**Subject: Point wise compliance/ reply of EDS regarding Diversion of 338.74 ha of forest land for Coal Mining in Barjora North Coal Mine Block in favour of The West Bengal Power Development Corporation Limited, Bankura District, West Bengal (Online Proposal No. FP/WB/MIN/43000/2019).**

**Ref:** (i) Query raised by DFO Bankura (North) Division vide Memo No.2502/8 on dated 25.11.2024

**Subject:** Point wise compliance/ reply of EDS regarding Diversion of 338.74 ha of forest land for Coal Mining in Barjora North Coal Mine Block in favour of The West Bengal Power Development Corporation Limited, Bankura District, West Bengal (Online Proposal No. FP/WB/MIN/43000/2019).

**PLATE-XVIII**

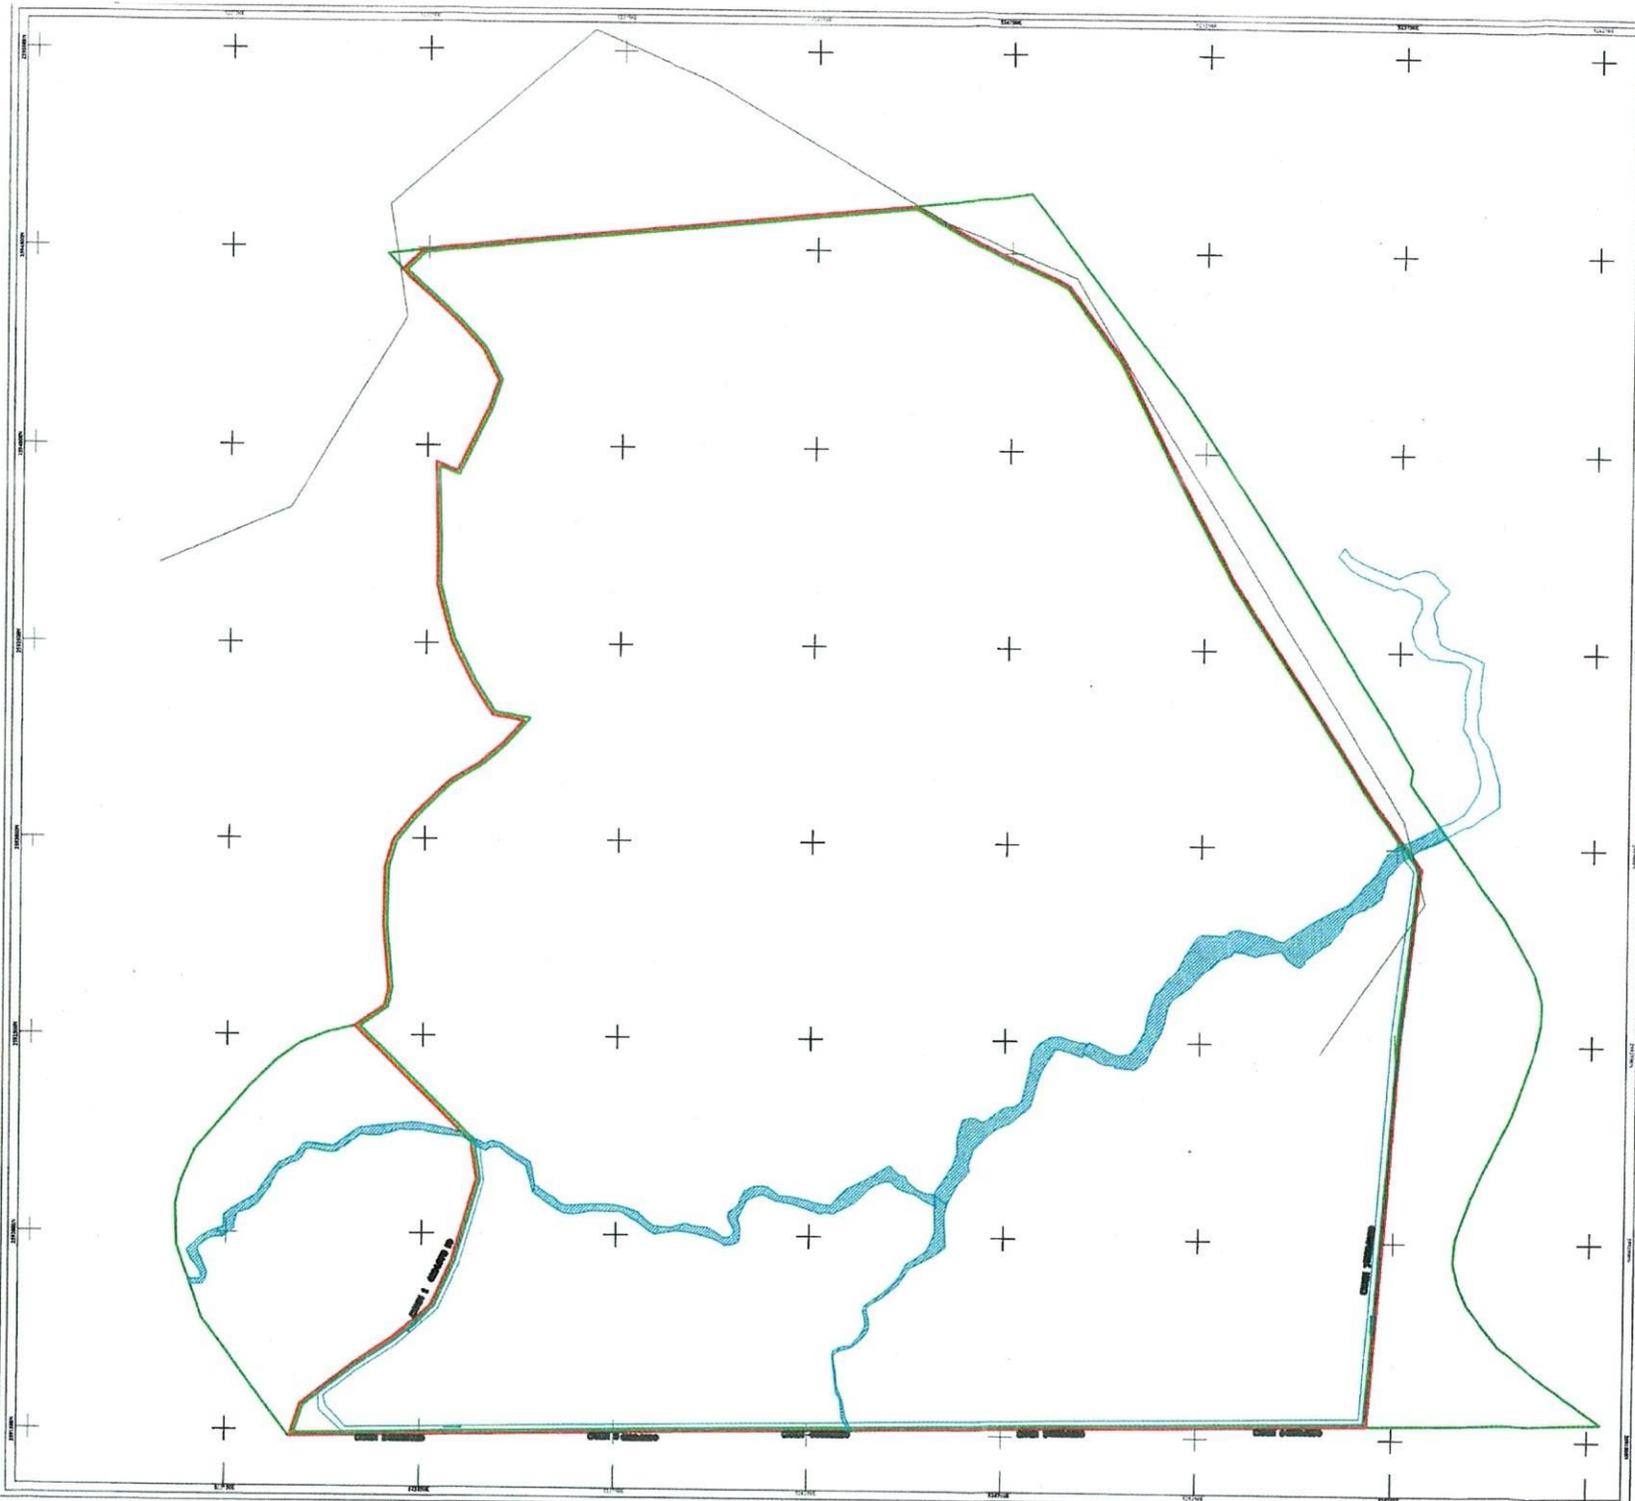
iii.	Justification for the diversion of the "Tartora Nala".	<p><u>Justification for the diversion of the "Tartora Nala".</u></p> <p>There are mainly three reasons for diversion of Tartora Nala.</p> <p><u>Approved Mine Plan:</u> As per approved Mine Plan &amp; Mine Closure Plan, the entire Nala falling within Core Mining Zone, therefore diversion is essential. Stage Plan of 10<sup>th</sup> to 15<sup>th</sup> year is Attached as <b>Annexure-II</b></p>

iii.	<p>The "Tartora Nala" flows from west to east of the proposed mine boundary and needs to be diverted as per the approved Mining Plan. A justification for the diversion of the Nala needs to be submitted. The state shall examine the matter and give a reasoned justification as to why the diversion of nala is essential and why it is not possible to retain the nala within the mining lease with a safety zone along the nala. The State Govt. shall submit no objection certificate from irrigation/water resource department with regard to the proposed diversion of the said nala.</p>	<p>As per Approved Mine Plan &amp; Mine Closure Plan, <b>Quote:</b> <i>"Diversion of Tartora Nala is expected to be completed between 10<sup>th</sup> to 15<sup>th</sup> year. At the end of 15<sup>th</sup> year stage Tartora Nala will be shifted completely".</i></p> <p><b>Unquote:</b> WBPDCCL will obtain all necessary permission/approvals from appropriate Authorities for diversion of the course of the Nala well in advance as per the progress of the mine.</p>

<p><u>Coal Reserve:</u> Beneath the Nala approx. 2.5 million tonne coal reserve is there, which cannot be left out as per Approved Mine Plan &amp; Mine Closure Plan by Ministry of Coal (MoC), Govt. of India.</p> <p><u>DGMS Safety Guidelines:</u> As per DGMS circular No. DGMS/SOMA/(Tech)circular no. 02, dated 22<sup>nd</sup> May,2024 Precaution against the danger of inundation due to the surface water &amp; underground water have been provided under Regulations 149 &amp; 150 of CMR,2017, &amp; DGMS Circular no. DGMS/SOMA/(Tech)Circular No. 02, dated 22<sup>nd</sup> May,2024 attached as <b>Annexure-III</b></p> <p>Therefore, if Nala is not diverted there will be threat of inundation during rainy season due to overflow and inrush of water by breaking the embankment when Mining Operations approach towards Nala,</p>
--	---

An existing Tartora nallah which flows from west to east, needs to be diverted along the southern edge of the proposed mine boundary. The elevation difference between the entry and exit points of this discharge scheme is about 8 meter. Total length of the diverted nala will be 6.30 km. Based on the present day flow parameters as observed at site, the base width and depth of the nala has been considered as 3 meter and 2.5 meter respectively. A more detail design needs to be done including cutting and filling requirement and vertical drop considerations before diversion of this nala. Chainage wise details of conceptual nala diversion is furnished Plate **No XVIII**. A declaration in this regard from M/S WBPDCCL has been furnished in **Annexure-XVIII H**.
